ADDENDUM NO. 22

Date: 09.15.2026

Project:
Westfield Washington School Corporation
Bid Package 06, Bid Item #33
SR32 & Centennial Road New Roundabout Construction
17707 Centennial Road,
Westfield, IN. 46074

1. All contractors shall review the attached A&F Engineering (and CSO Architects) Addendum #22 Dated 09.15.2026 and incorporate the changes made to the drawings and specifications into the respective bid item scope of bid.

STANDARD DRAWING NO. **E 807–LTHH–01**

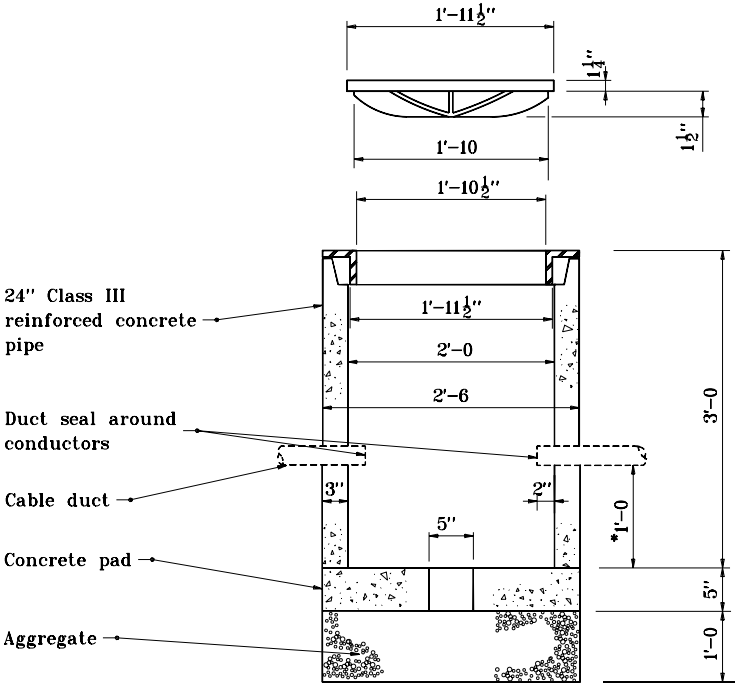
4. Please add the following sketches to the bid set of Drawing and Scope of Bid: Light Handhole Detail Drawing Standards No: E 807-LTHH-01, E 807-LTHH-02 and E 807-LTHH-03, copies attached to be included with your bid. Please add these sketches to Drawing 24 of 47.
